ANN ARBOR HISTORIC DISTRICT COMMISSION

Staff Report

ADDRESS: 620 Third Street, Application Number HDC13-047

APPLICATION: The applicant seeks HDC approval to construct a second story on an existing rear one-story wing.

620 THIRD STREET -- PROPOSED SITE PLOT

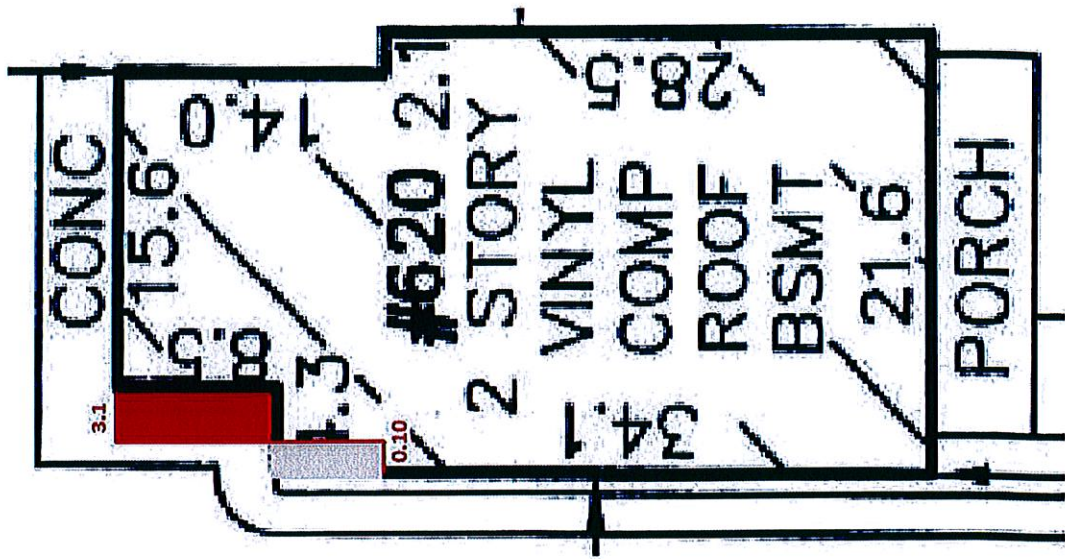
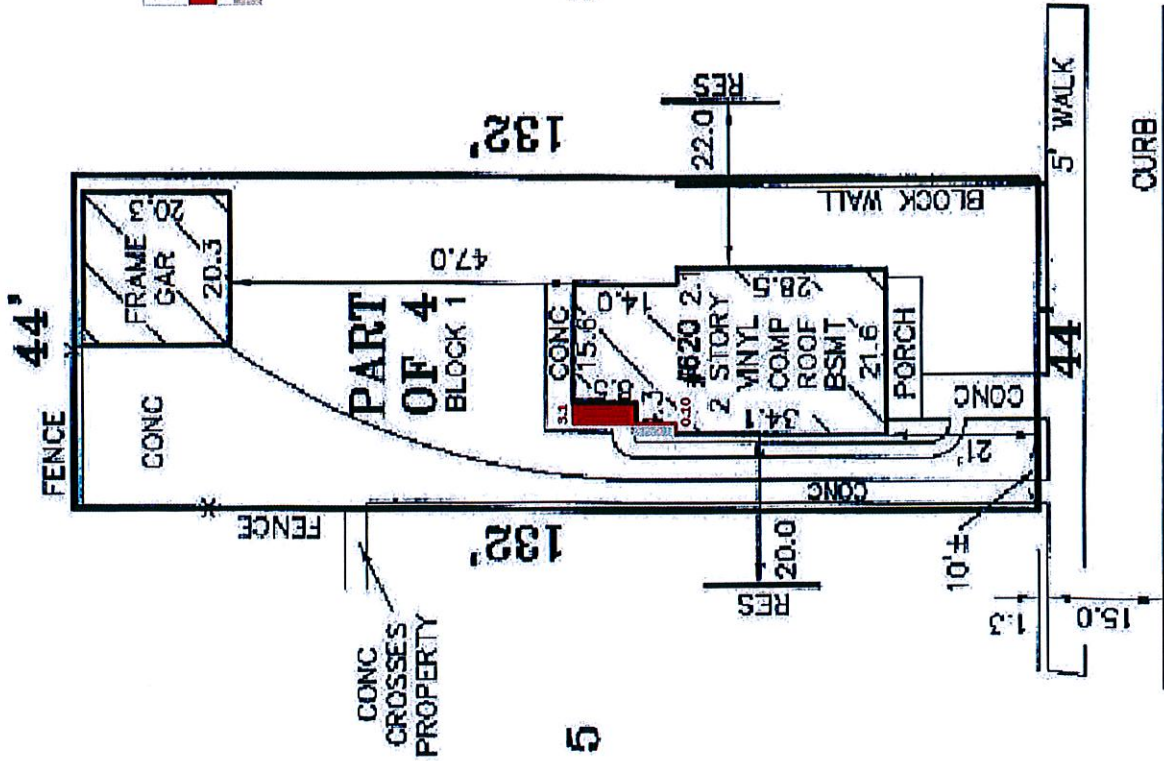
3. A small mudroom would be removed from the west elevation in the corner where the main house meets the addition. The west wall of the kitchen would be moved out 3 feet, with the resulting wall inset 10" from the corner of the original house. A second story with an additional bedroom and expanded bath would be placed on top of this new footprint.

PROPOSED SOUTH ELEVATION
SCALE 1/4" = 1'-0" ON 11x17" PAPER

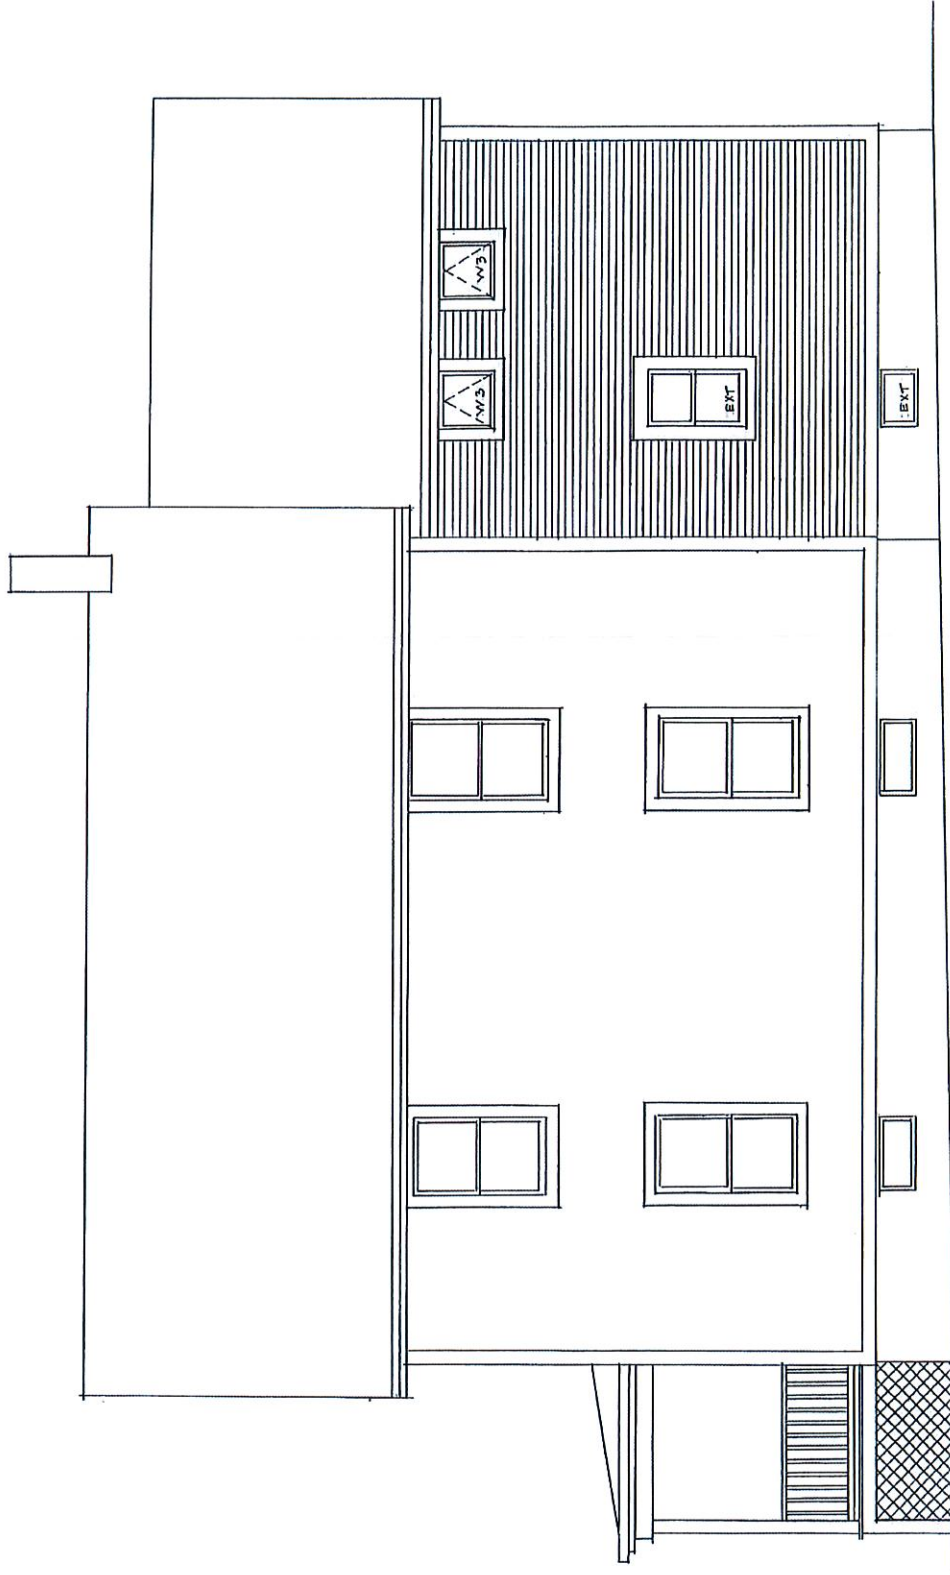
6. The addition is simple and compatible in massing to the main house and neighborhood, and the massing of the addition keeps the house similar to neighboring houses in terms of the relationship of open space to structure on the lot. The addition is differentiated from the house mainly by the square awning windows on the south and north elevation of the second floor.

PROPOSED WEST ELEVATION

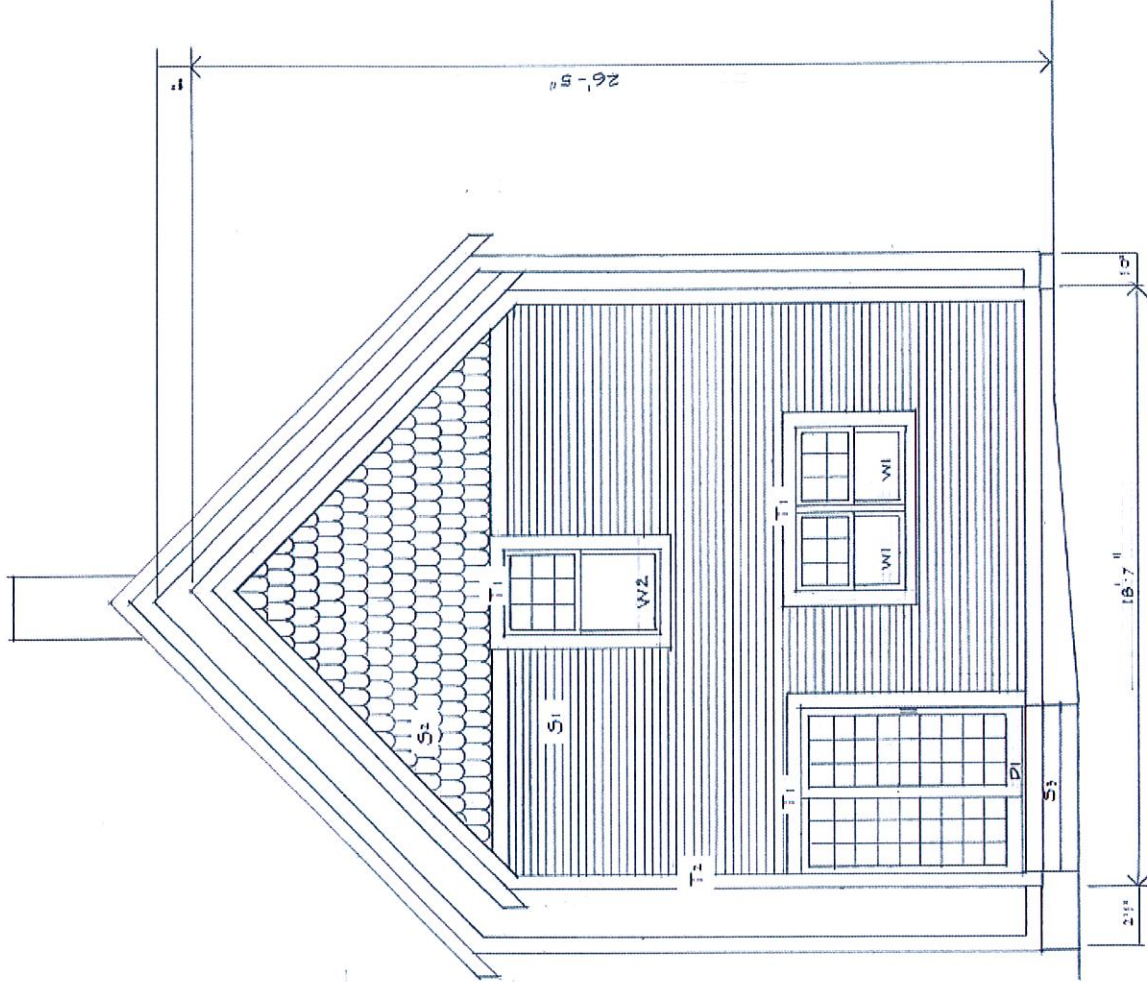
5. The proposed west elevation is proposed to have vinyl fish-scale shingles in the gable, three vinyl-clad wood double-hung windows with divided lights in the top sash, and a vinyl-clad wood French door with divided lights. The muntins would be applied on both the exterior and interior. Staff feels that adding these elements is conjectural, since there is no evidence that the windows were not one-over-one originally (per the 1990 photo) or that there were ever fish-scales elsewhere on the house. The use of vinyl siding on the addition is consistent with the rest of the house, which probably has several layers of siding. If the commission feels that the use of vinyl shingles and vinyl-clad windows instead of wood would prevent these elements from being misread as original, the conditions should be removed from the motion suggested by staff.

I move that the Commission issue a certificate of appropriateness for the application at 620 Third Street, a contributing property in the Old West Side Historic District, to remove a mudroom, move the west wall of the rear addition, and construct a new second floor on the rear addition, on the following conditions: 1) the siding in the new rear gable matches that of the rest of the addition, and 2) the windows and French door on the west elevation do not have divided lights. The work as conditioned is compatible in exterior design, arrangement, texture, material and relationship to the rest of the building and the surrounding area and meets *The Secretary of the Interior's Standards for Rehabilitation and Guidelines for Rehabilitating Historic Buildings*, in particular standards 2, 3, 9 and 10 and the guidelines for additions and building site; and the *Ann Arbor Historic District Design Guidelines* for additions.
